Office Action Summary

10/568,808

Claims 1-9 are rejected under 103(a) as being unpatentable over Ezaki et al.

(Ezaki), US PUB 2004/0114425.

FIG. 7

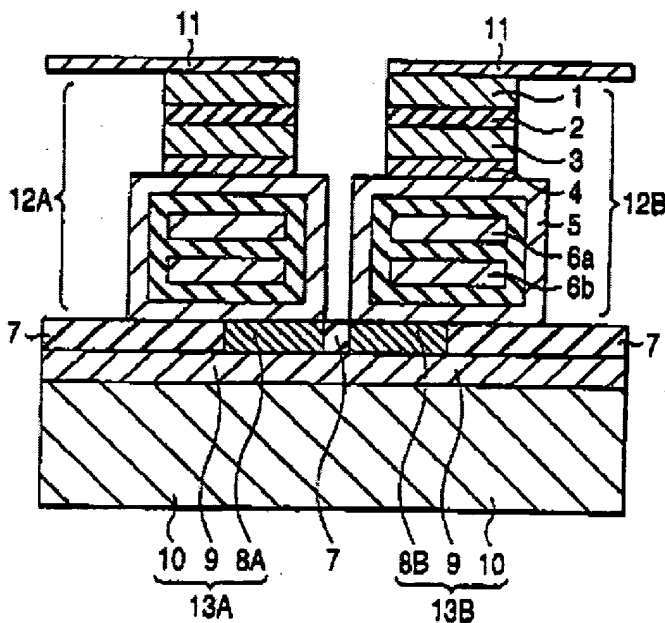
Regarding claims 1, 2, & 4, Ezaki discloses (page 3, para 0020) and shows in figure 7:

- a plurality of magnetoresistance elements each including a laminate including a magnetosensitive layer having a magnetization direction variable in accordance with an external magnetic field and adapted to allow an electric current to flow in a direction perpendicular to a laminated surface of the laminate;
- an annular magnetic layer disposed on one surface side of the laminate;
- figure 7 shows the annular magnetic layers [5] arranged side by side.

Furthermore, Ezaki discloses the claimed invention except for the magnetosensitive layer having a thickness set in a range of not less than 0.5 nm, to not more than 40 nm. It would have been obvious to one of ordinary skill in the art at the time of the invention was made to modify Ezaki, since it has been held that where the general conditions of a claim are disclosed in the prior art, discovering the optimum or working ranges involves only routine skill in the art. In re Aller, 105 USPQ 233.

Regarding claim 5, figure 7 shows a plurality of the conductors [4] extending through the plurality of annular magnetic layers [5], and the plurality of the conductors

extend in parallel to each other in a region where the plurality of the conductors extend through the plurality of annular magnetic layers.
